Service Bulletin

Bulletin No.: 21-NA-149

Subject: Engine Wire Harness Chafing / IPC Gauges Sweep / IPC Warning Message / SES/Check Engine/MIL / No Start / No Crank / Runs Rough / Stalls / Reduced Engine Power / Various DTCs

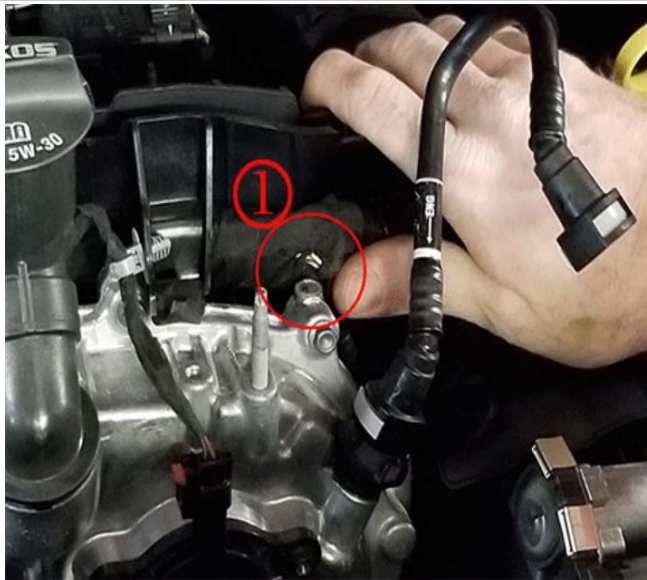
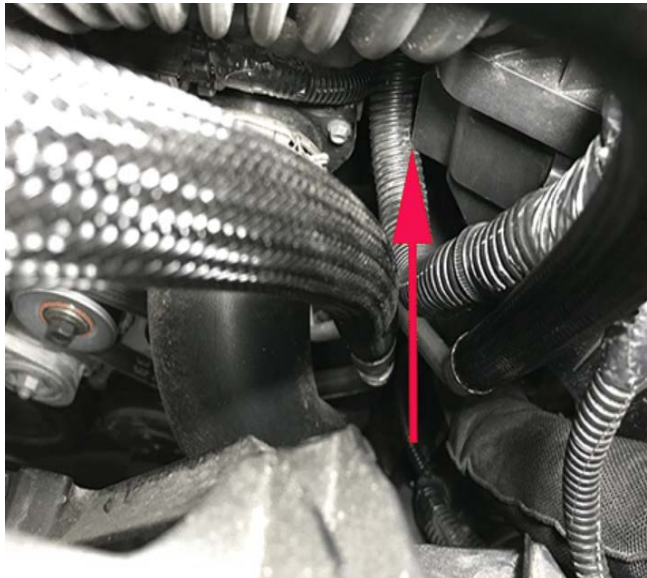
<p>Cause 1</p>	<p>This Cause pertains to vehicles equipped with engine 2.7L, L3B only.</p> <p>These concerns may be caused by engine harness contact with under hood components.</p> <p>Caution: This Document Only Applies To VINs NOT Covered by Customer Satisfaction Program N192219370 Please Verify In VIS Before Proceeding</p> <p>Shown below are areas that should be inspected for this concern.</p> <p>Inspect the engine harness as it crosses over top of the Camshaft Carrier Cover.</p> <p>Harness damage can occur at any point across the Camshaft Carrier Cover.</p> <p>Typical inspection locations shown below.</p>  <p>Example of engine wiring harness damage at Camshaft Carrier Cover shown below.</p>

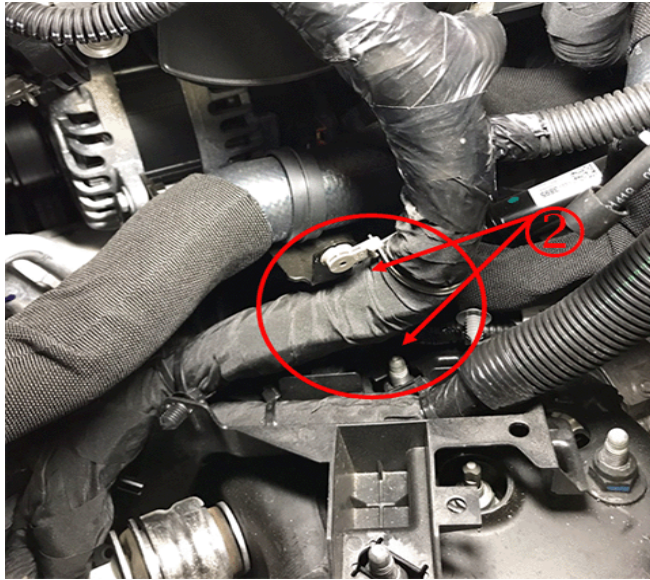
Inspect the engine harness at the Lower Air Cleaner Housing as shown below.

Example of engine harness damage, Lower Air Cleaner Housing removed shown below.

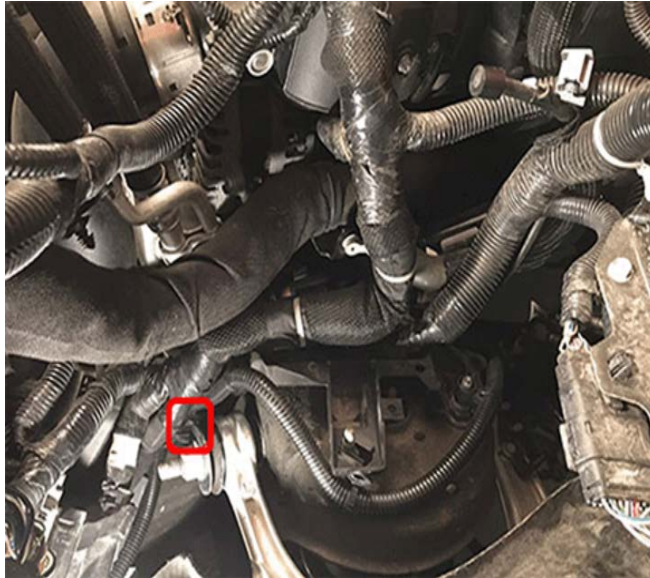
Inspect the engine harness at the Generator Bracket and Left Front Coil Spring stud as shown below.

Note: Under normal driving conditions, the engine will rock back and forth in its mounts.

This may result in harness contact with this bracket that may not be present during engine off inspections.

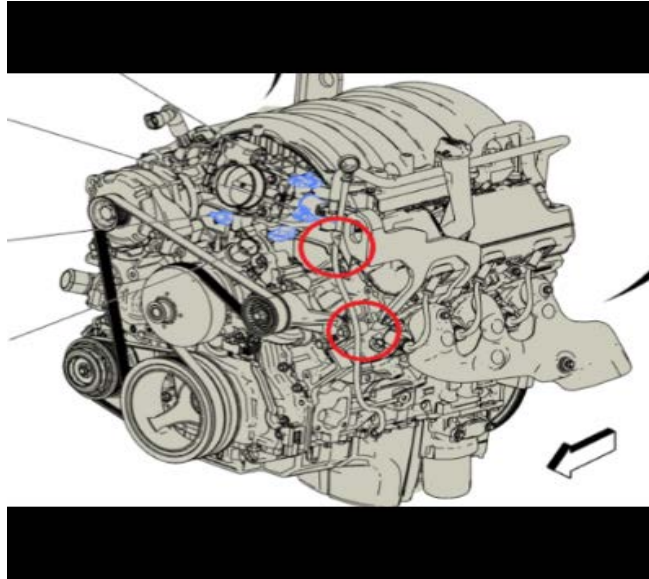
Inspect the engine harness at the Left Front Upper Control Arm Bushing as shown below.

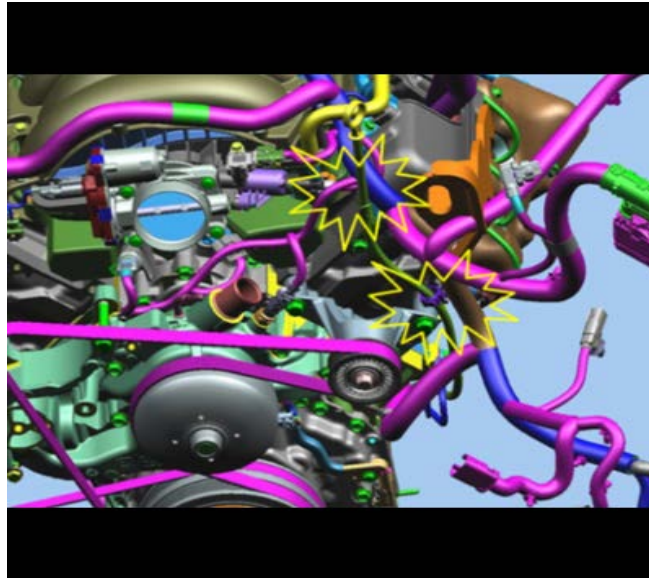
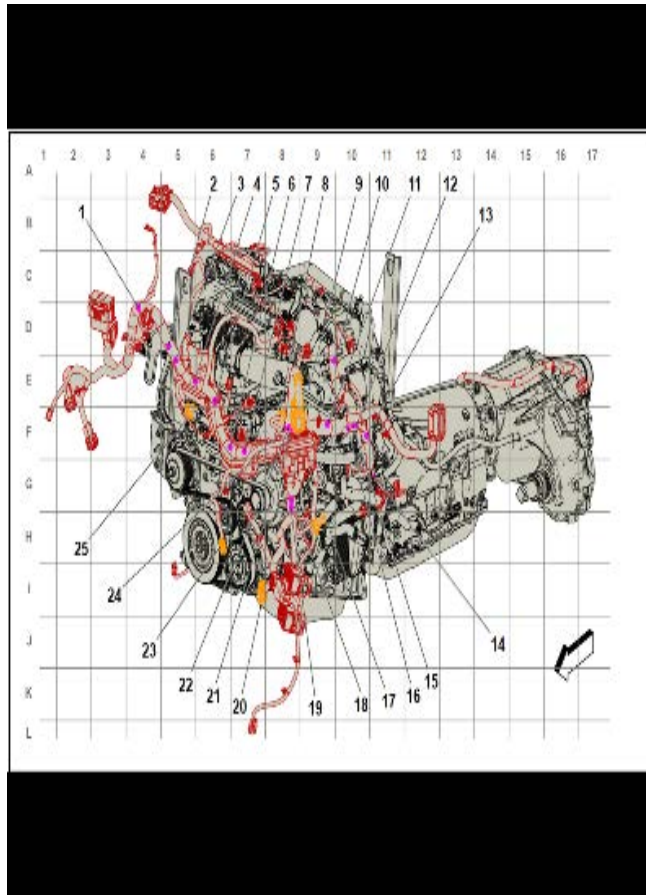
These concerns could be caused by engine wiring harness chafe on underhood components at various locations such as: Front corner of the left hand cylinder head, drive belt idler pulley bracket, or oil dipstick bracket; noted by the circled and starred areas in the graphics above.

This harness chaffing could cause shorting of any number of circuits to ground. Due to the number of circuits in the harness, there is a wide variety of different symptoms that could occur depending on which circuit(s) are damaged.

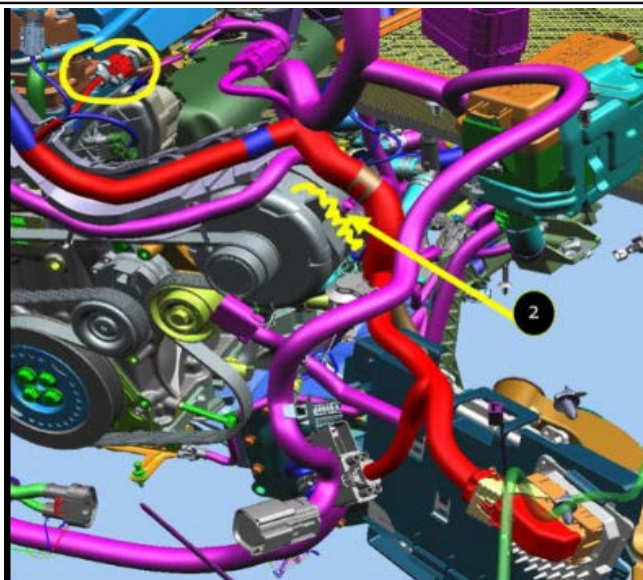
1. The engine harness pinched/shorted/chaffed at grid coordinates G-8, as shown above. This location is approximately 18 inches from the ECM connectors (1) and on top of the generator (2), as shown below. Due to the number of circuits in the harness, there is a wide variety of different symptoms that could occur, depending on which circuit(s) are damaged.

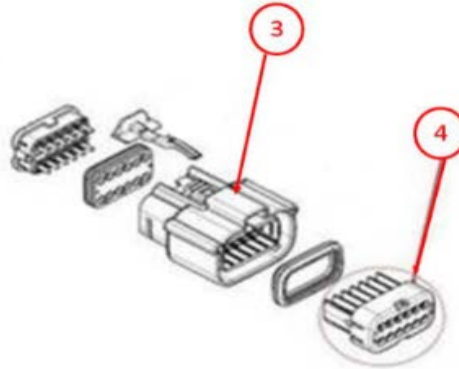
2. The engine harness shorted/chaffed at grid coordinates C-9, as shown above. The engine harness could be shorted out on the PVC hose clamp at the crankcase pressure regulator, as shown below (6). This is located approximately 4 inches from the crankcase sensor connector pigtail harness breakout.

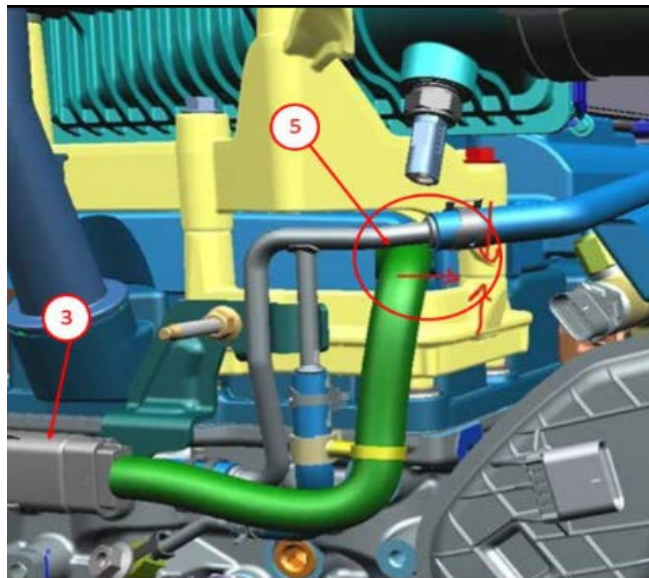
1. Inspect for poor terminal tension at connector X160, shown in the grid above, as callout 25. While inspecting X160 make sure the terminal locking feature (4), shown below, is not missing.

2. Inspect the fuel injector connectors to make sure they are fully connected/seated.
3. Inspect the fuel injector wiring harness near the X160 connector (3) for being pinched/shorted/chaffed, as shown below (5).

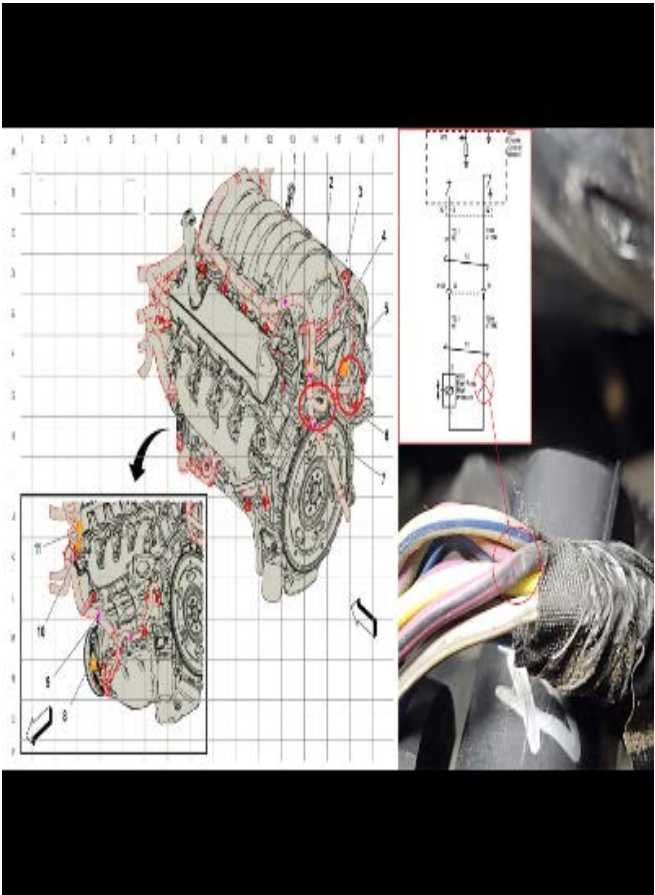
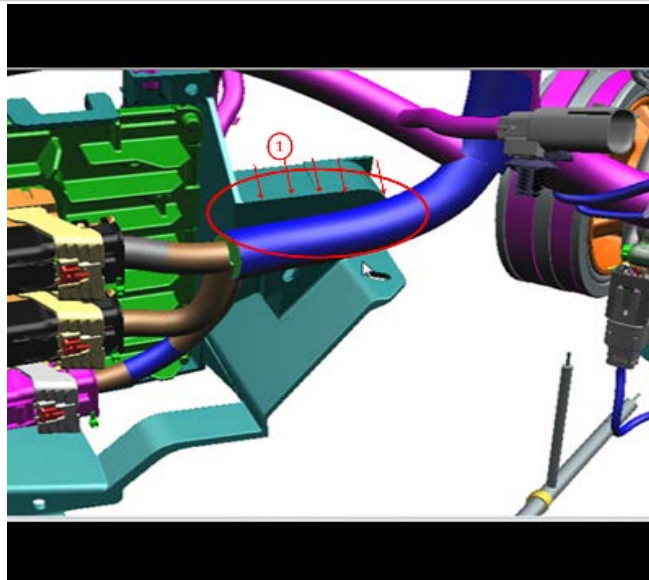
Examples of extreme wire chaffing.

An example of firewall insulator chaffing

Other areas of concern.

The cause of the condition may be an engine wire harness clip was removed during production due to ergonomic issues (hand clearance and branch stiffness). This led to an uncontrolled branch that came into contact with a sharp edge (1) & (2) on the ECM/TCM bracket, driver side upper control arm, and/or shock tower and caused chaffing during engine vibration and roll.

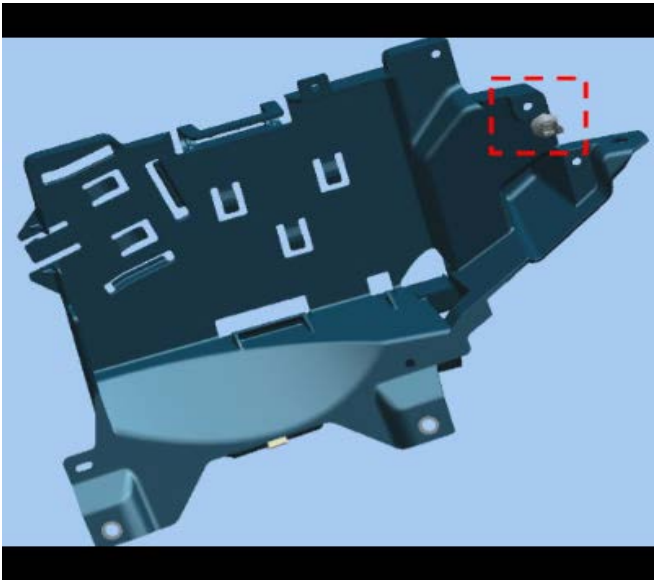
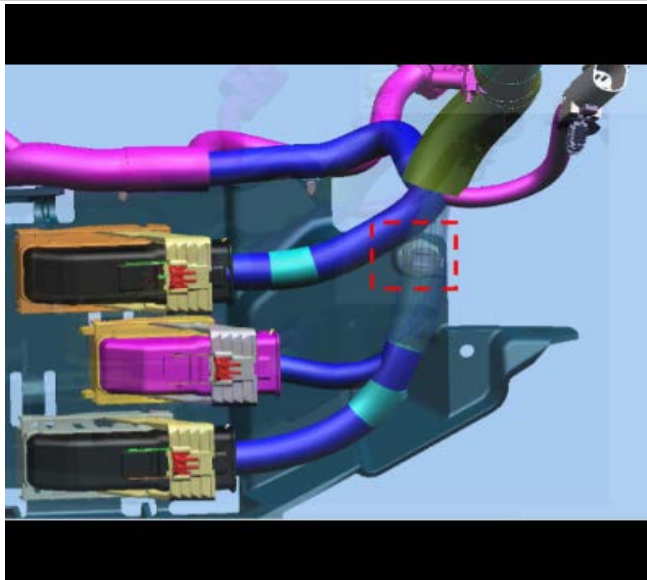
Protect the engine wiring harness from future damage at the ECM Bracket.

Install a Zip Tie Fir Tree Clip GM PN 84389052, 28 millimeters below the branch break out from above as shown below.

Insert the Zip Tie style Fir Tree Clip into the location shown below in the ECM Mounting Bracket.

Zip Tie Fir Tree Clip installed securing the harness as show below.

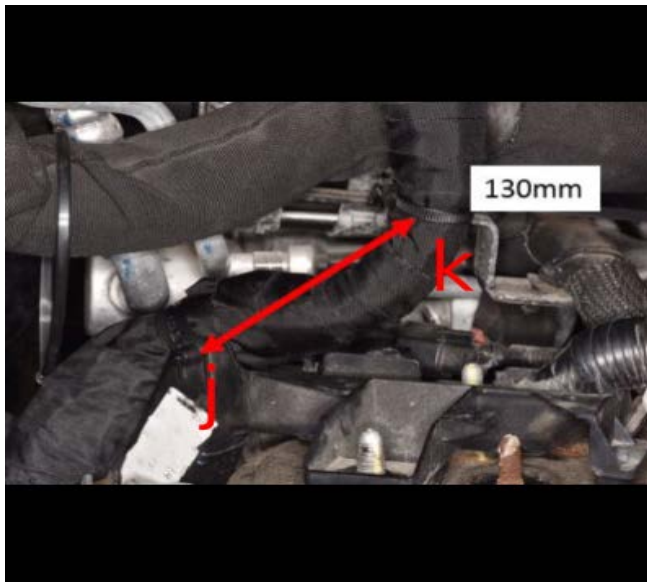
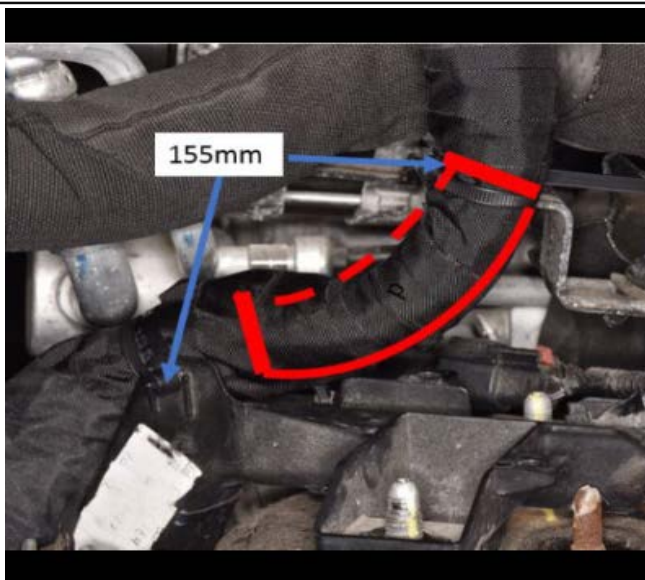
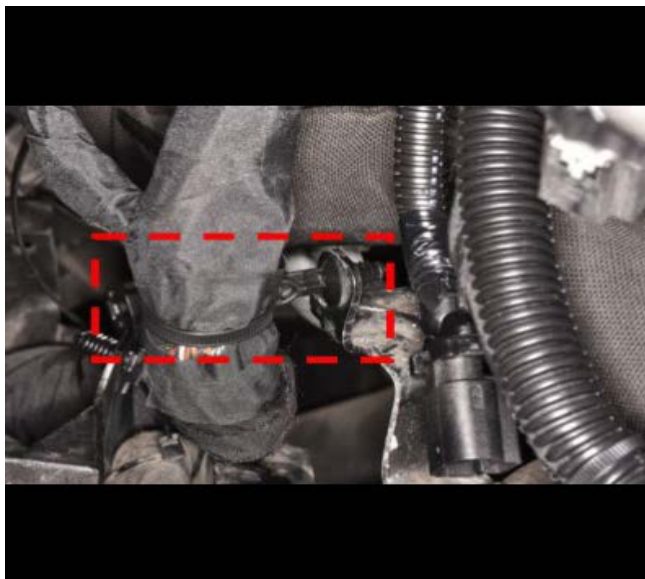
Protect the engine wiring harness from future damage at Generator Bracket.

Zip Tie style Fir Tree Clips are located on the plastic Channel at #1 and on the Generator Bracket at #2 shown below

Measure up 155 mm from the Zip Tie style Fir Tree Clip located on the plastic Channel.

Install the Kevlar Velcro Sleeve PN 84820678 155 mm up the engine wiring harness as shown below to ensure that the sleeve extends 25mm above the Zip Tie style Fir Tree Clip located at the Generator Bracket as shown below.

Tape both ends of the Kevlar Velcro Sleeve with Woven Polyester (PET) Electrical/Anti-Abrasive Tape using KENT® AUTOMOTIVE 1089482 to secure in place.

Install the updated Zip Tie style Fir Tree Clip GM PN 13596790 in the Generator Bracket as shown below.

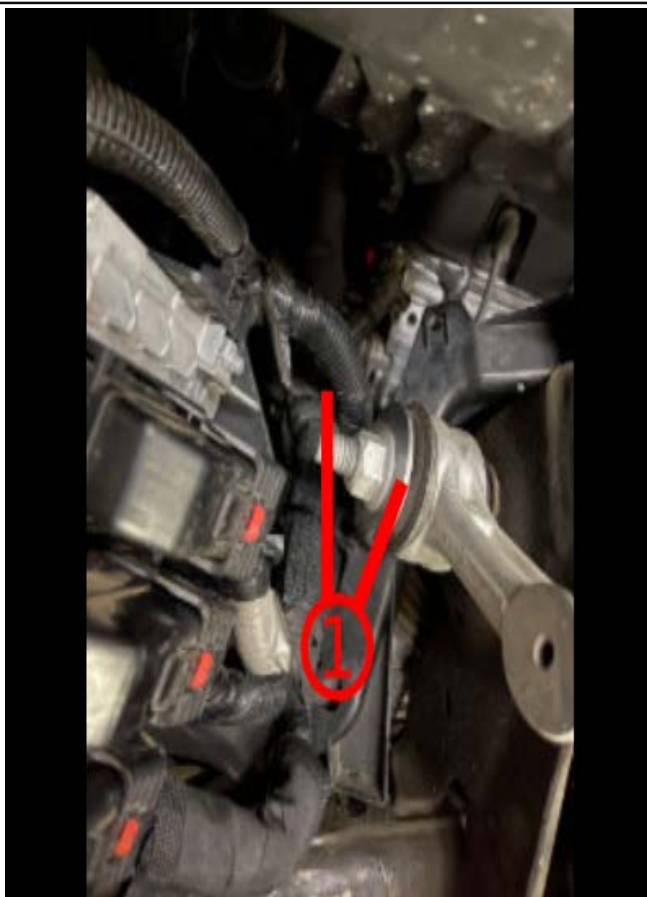
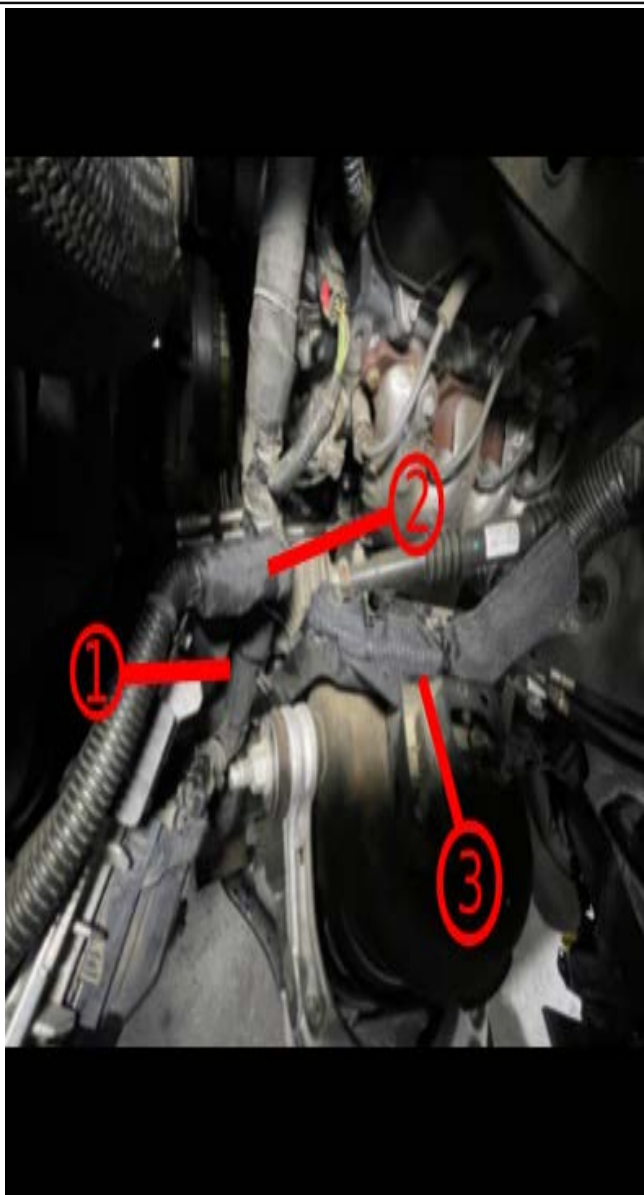
3. Locate the three contact points where the wire harness is chaffing, the ECM/TCM black bracket (1), the upper control arm (2), and the shock tower bolt (3).

4. At the ECM/TCM bracket, locate the wire harness laying against the ledge (1).

5. Wrap the wire harness with the shorter Engine Harness Sleeve then utilizing zip ties and two small holes in the bracket (1).

6. Secure the harness snug to the bracket to prevent movement.

7. At the upper control arm (1), secure the harness away from control arm (example above shows harness in the correct position, unwrapped).

8. Wrap the harness in the shorter Engine Harness Sleeve then wrap with anti-abrasion tape secure it to the harness clip above the ECM/TCM bracket (1) to keep out of the way of the upper control arm.

10. Using the long Engine Harness Sleeve, wrap the harness and secure it snug to the canal using zip-ties.
